## ADDENDUM

NO. 01

**PROJECT NAME:** 2025 Multi-Campus Chiller Replacement

**CLIENT NAME:** Cypress-Fairbanks ISD

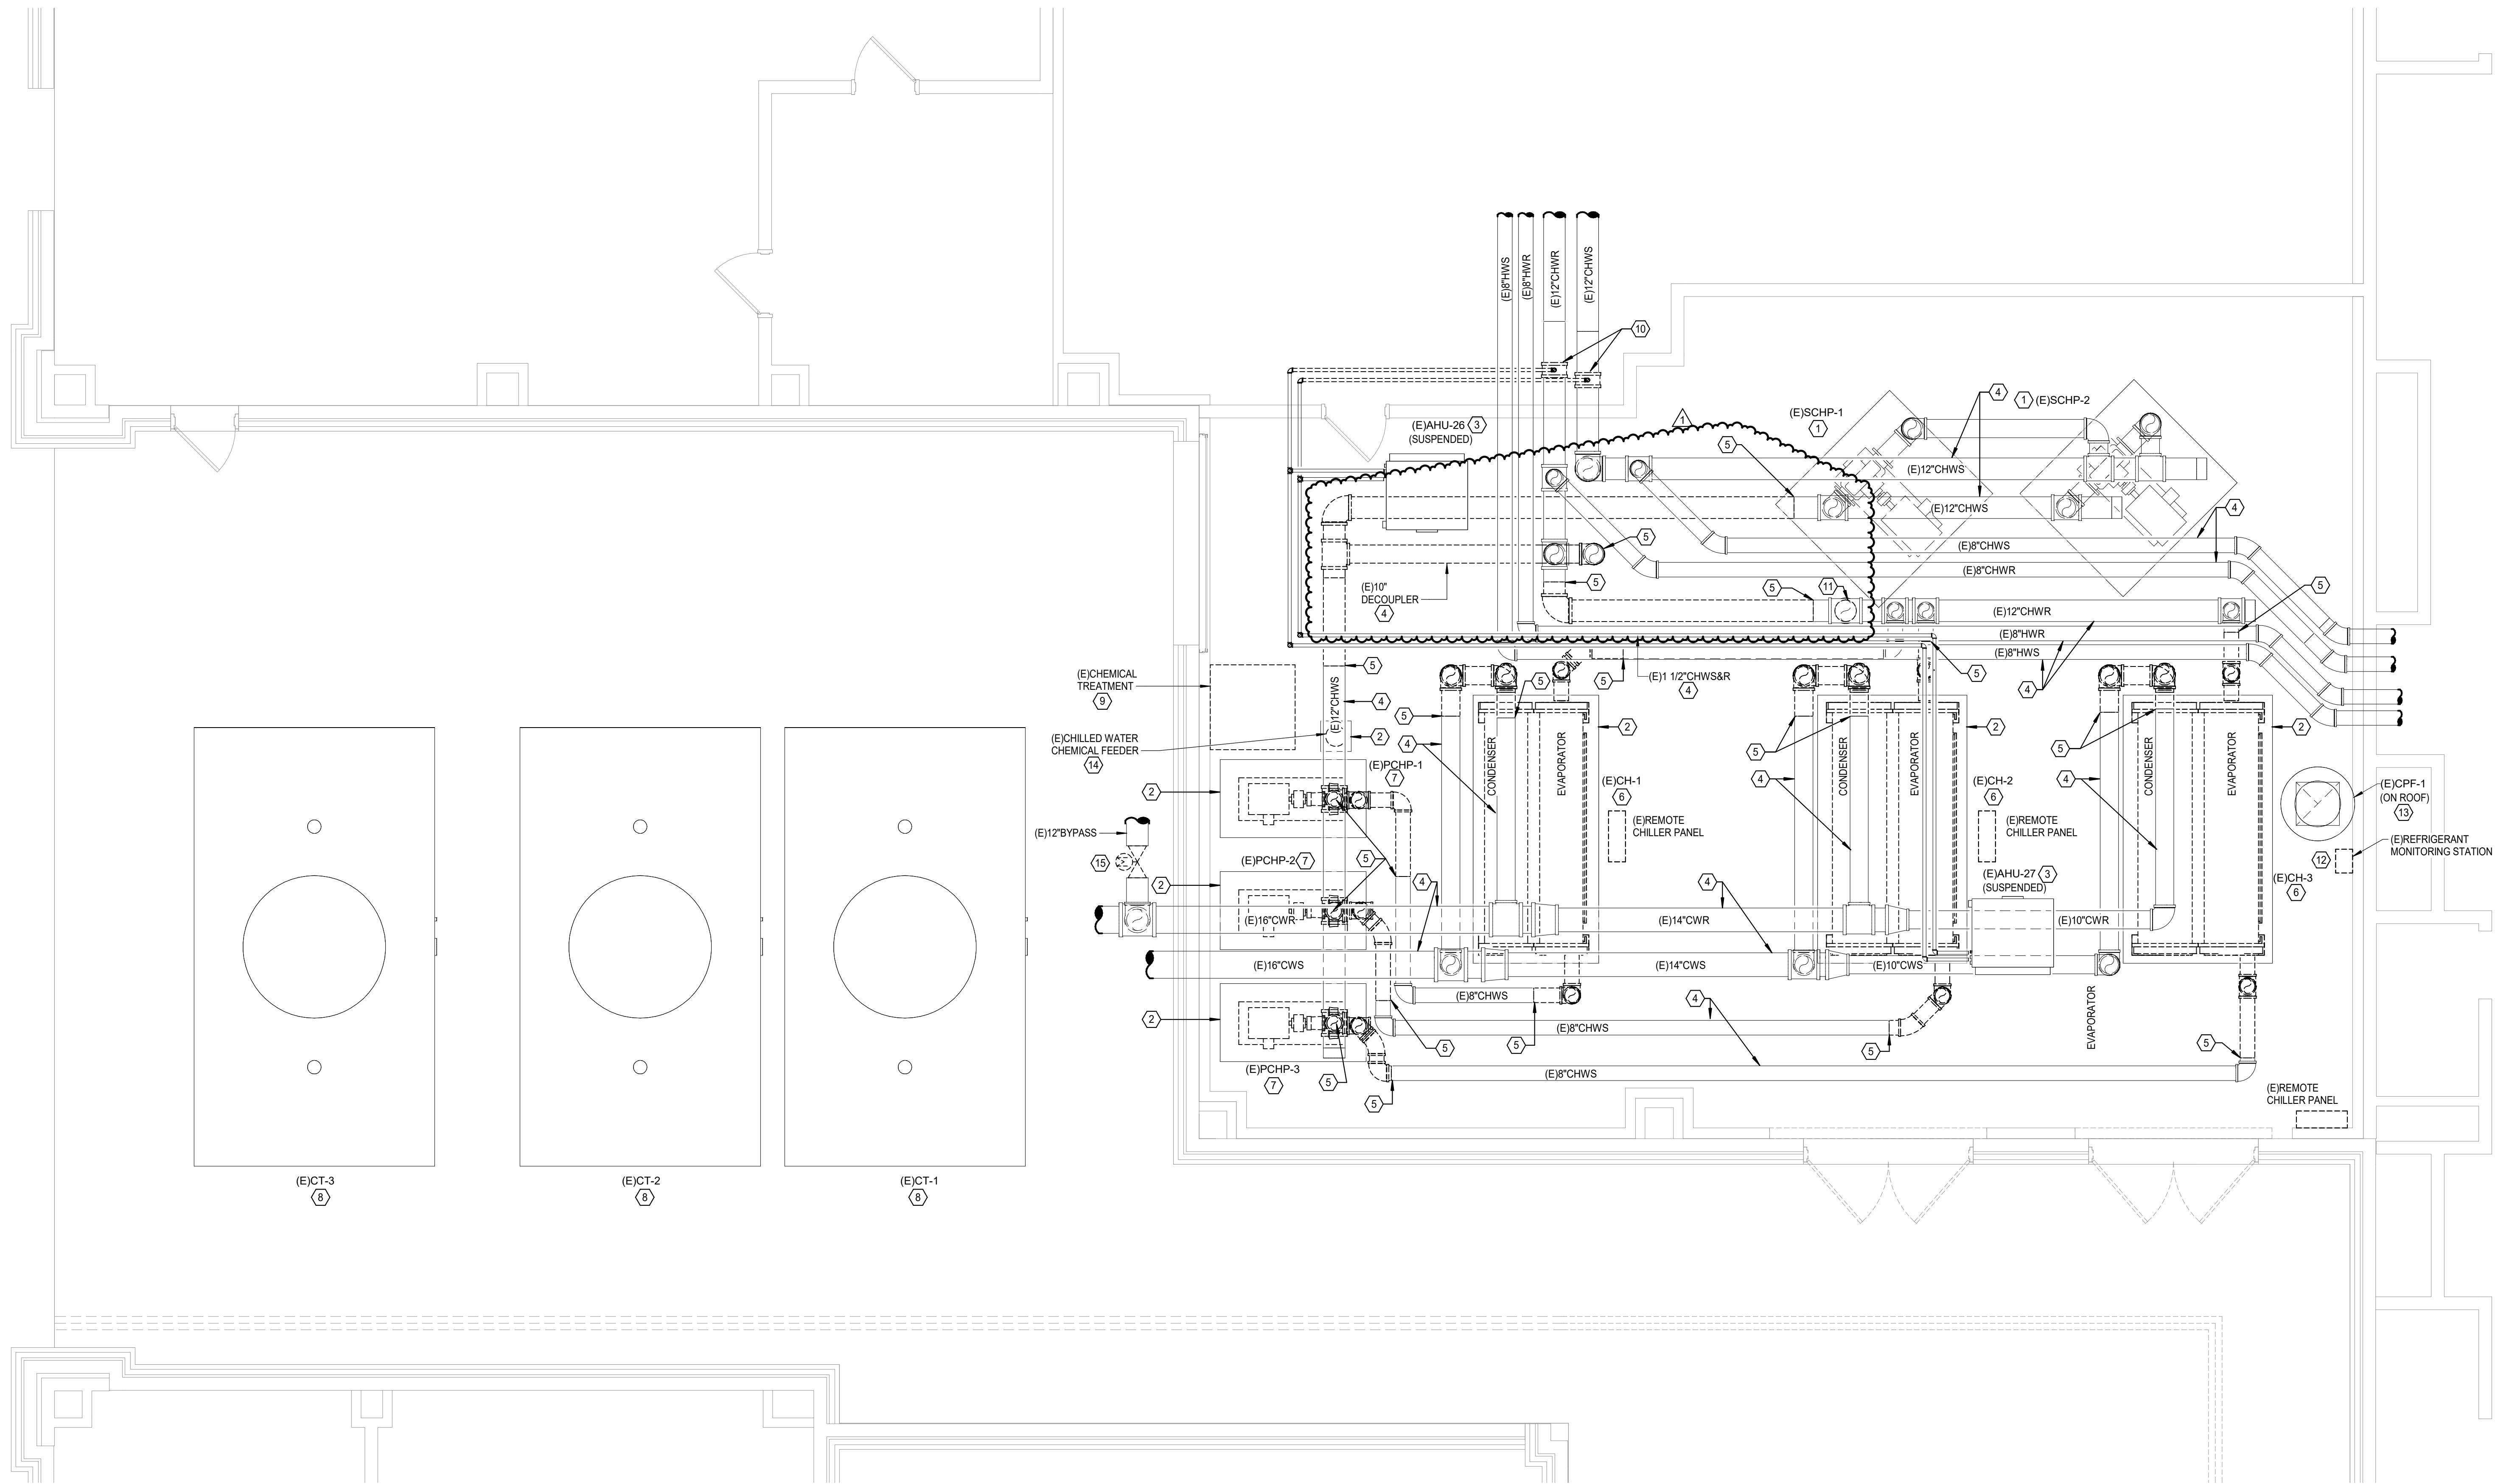
AD No 1, Arch. Item 6: **To the Drawings, Sheet G2.01-BC - "MASTER SITE PHASING PLAN"**

- 1) Revise the list of rooms to receive dehumidification at the Berry Center per the revised sheet

MECHANICAL DEMO  
ENLARGED PLAN - SECOND  
FLOOR - SERVICE YARD

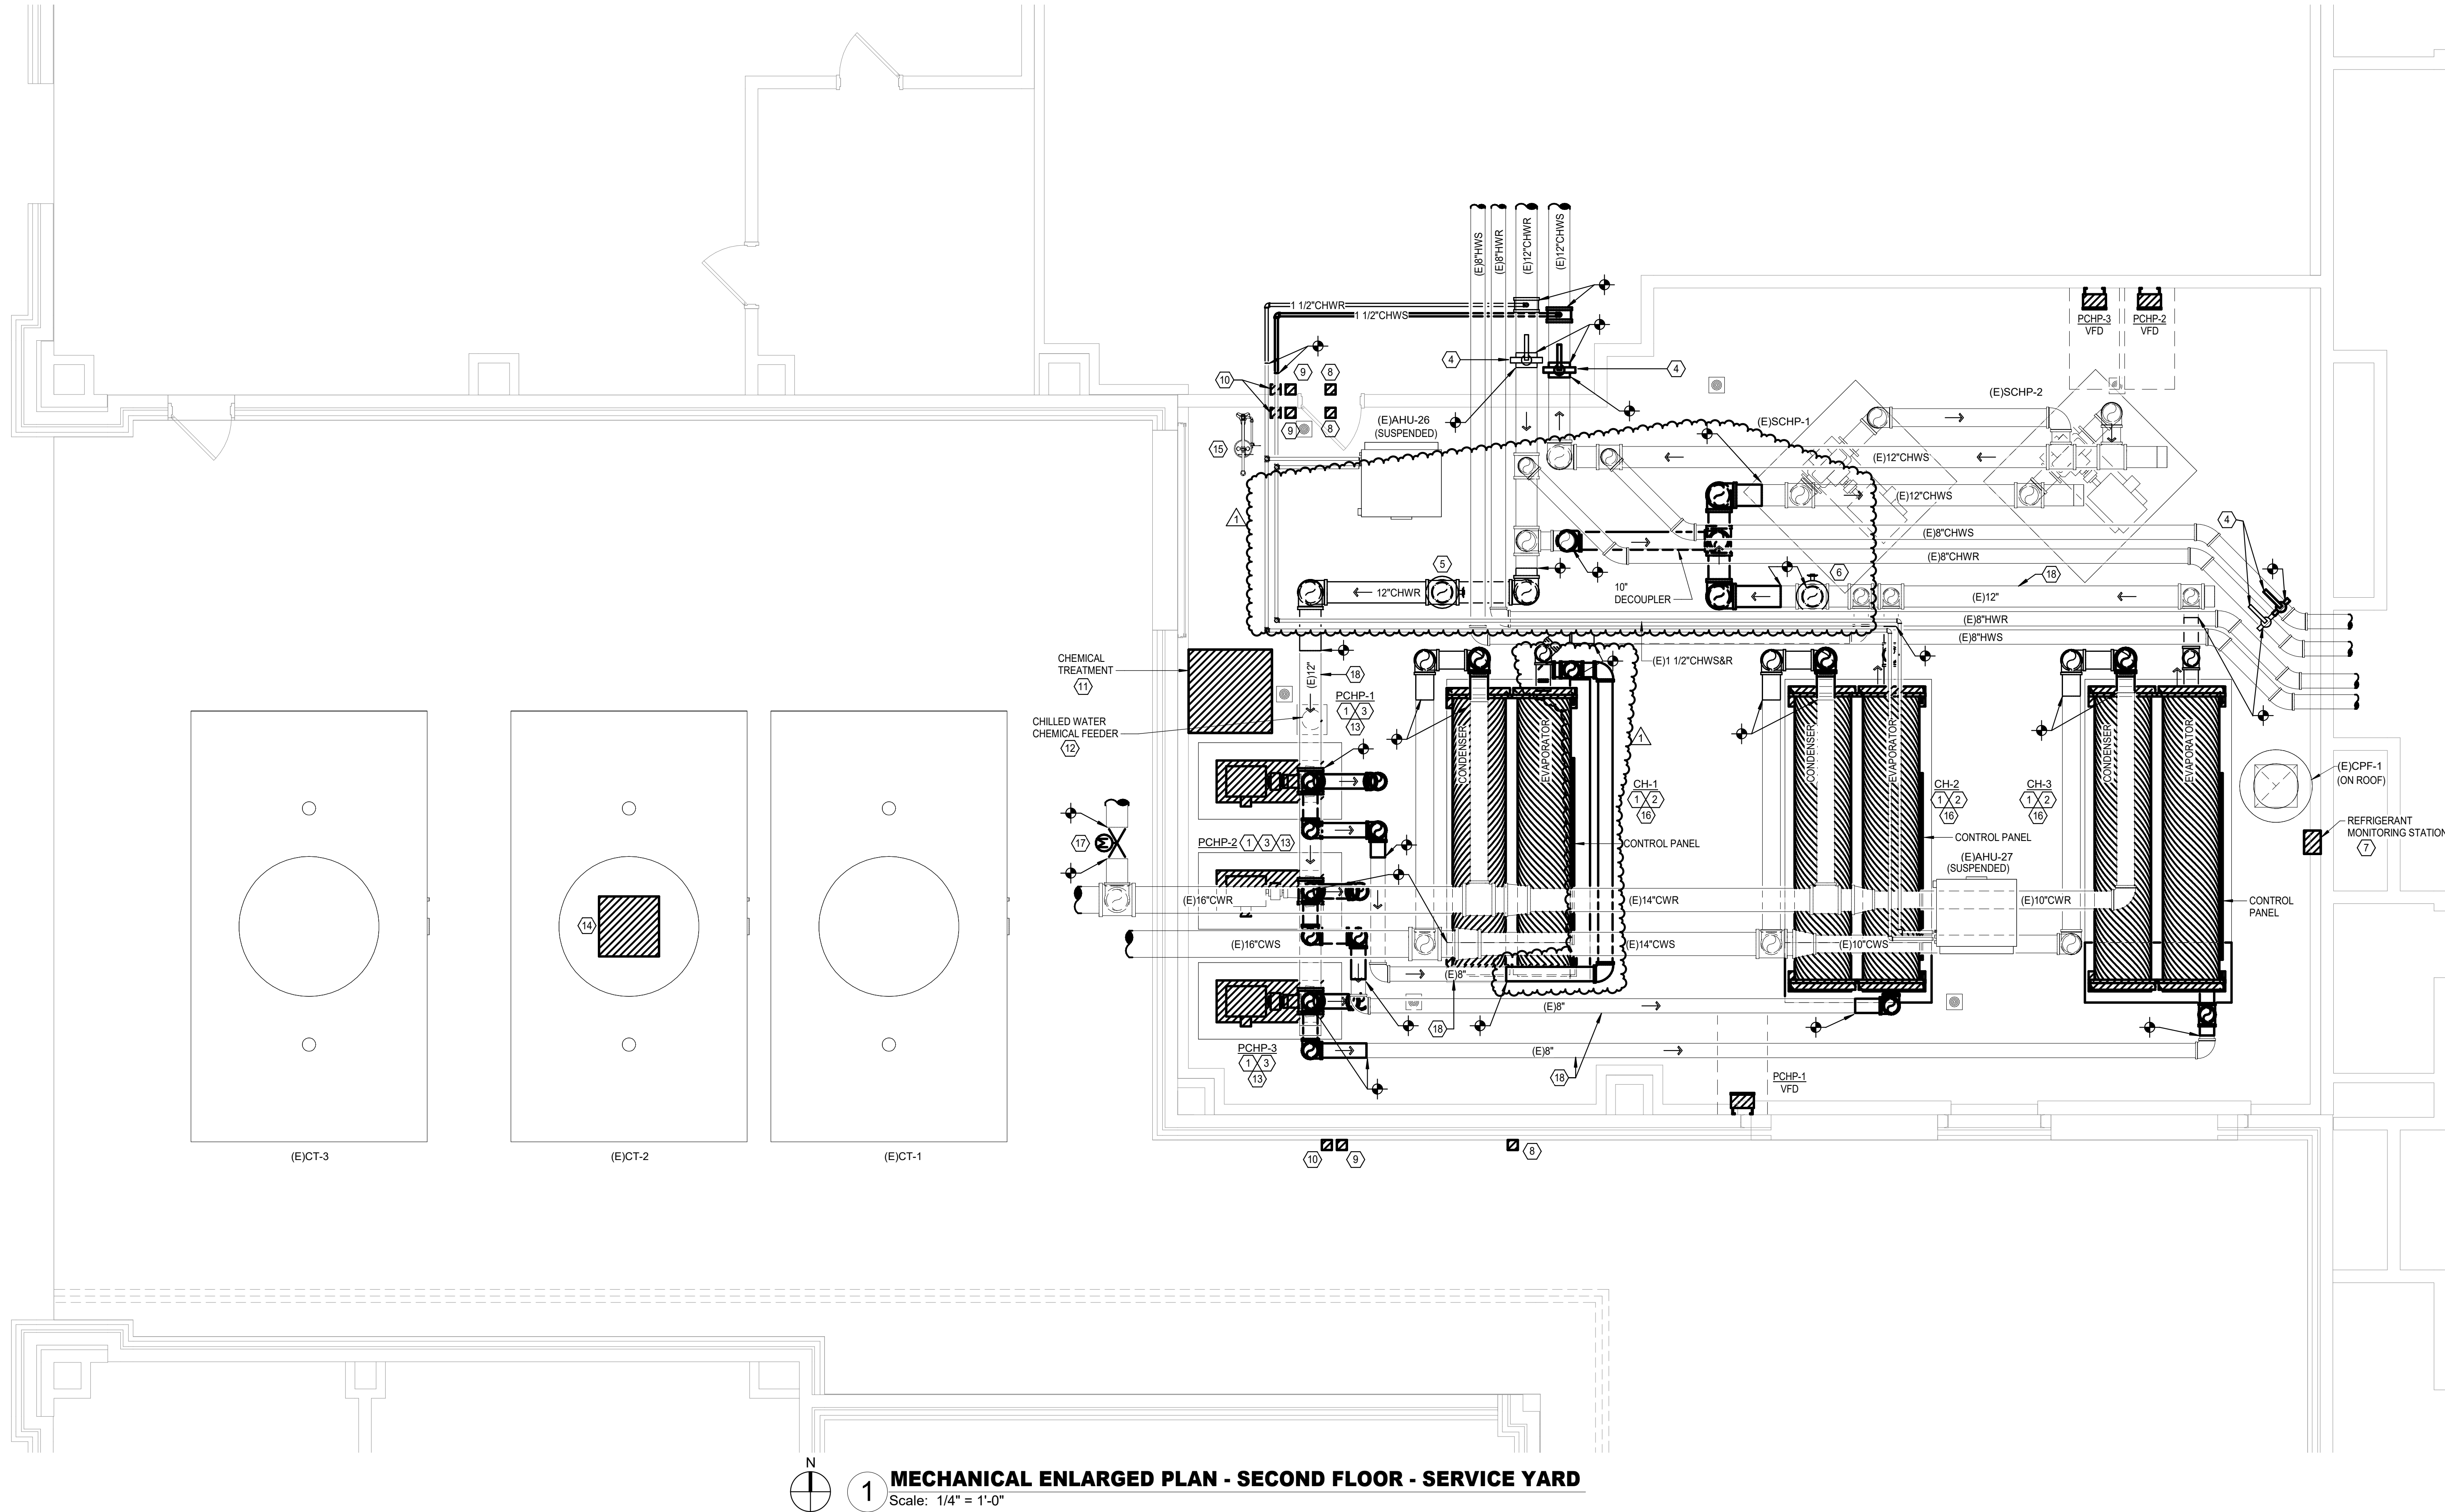
AD No 2, Mech. Item 2: **To the Drawings, Sheet M0.01-BC, "MECHANICAL DEMO ENLARGED PLAN – SECOND FLOOR – SERVICE YARD"**

- a. Refer to attached drawing for revised decoupler.

Job No.  
01818-08-04  
Sheet No.  
M2.01-BC  
Date  
08/11/2025

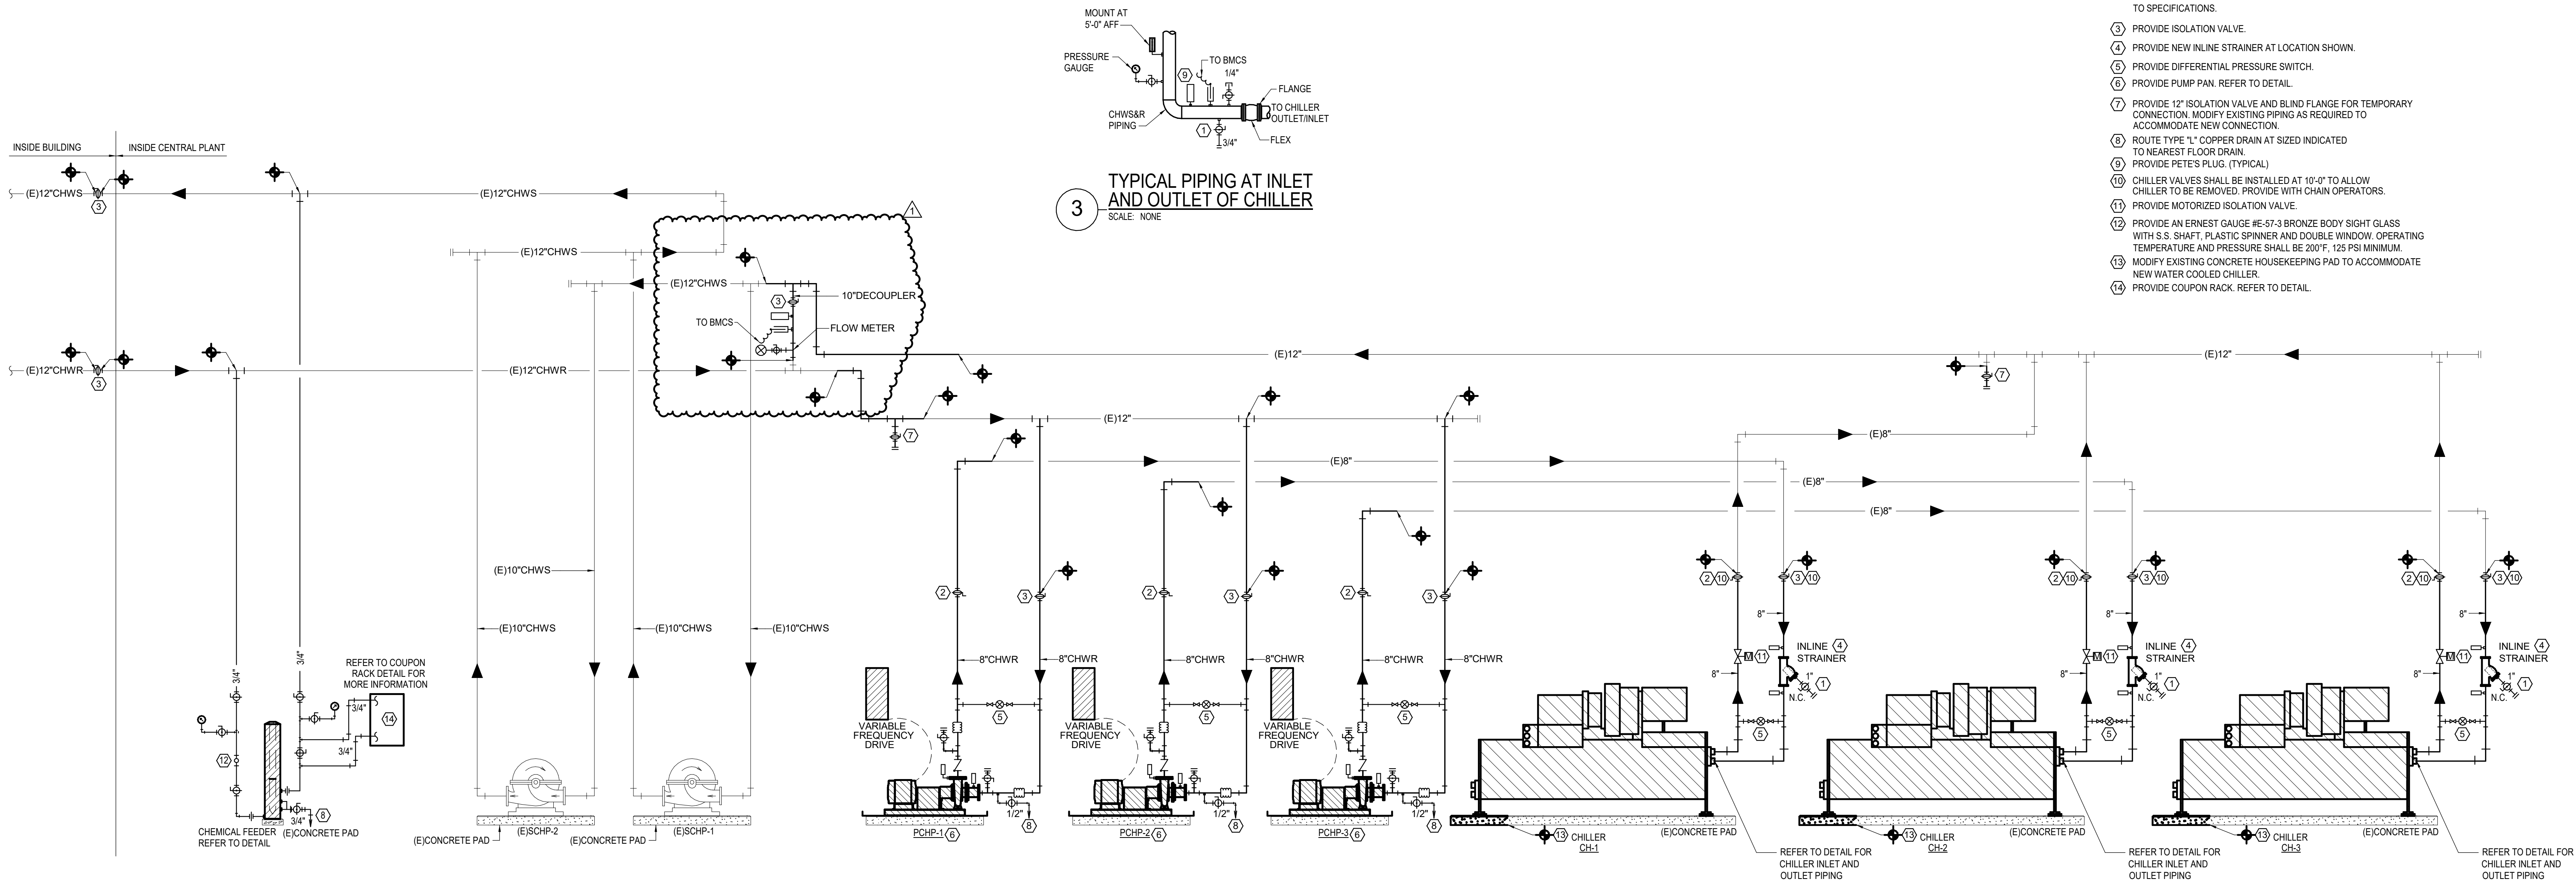
AD No 2, Mech. Item 3: **To the Drawings, Sheet M2.01-BC, "MECHANICAL ENLARGED PLAN – SECOND FLOOR – SERVICE YARD"**

- a. Refer to attached drawing for revised decoupler.
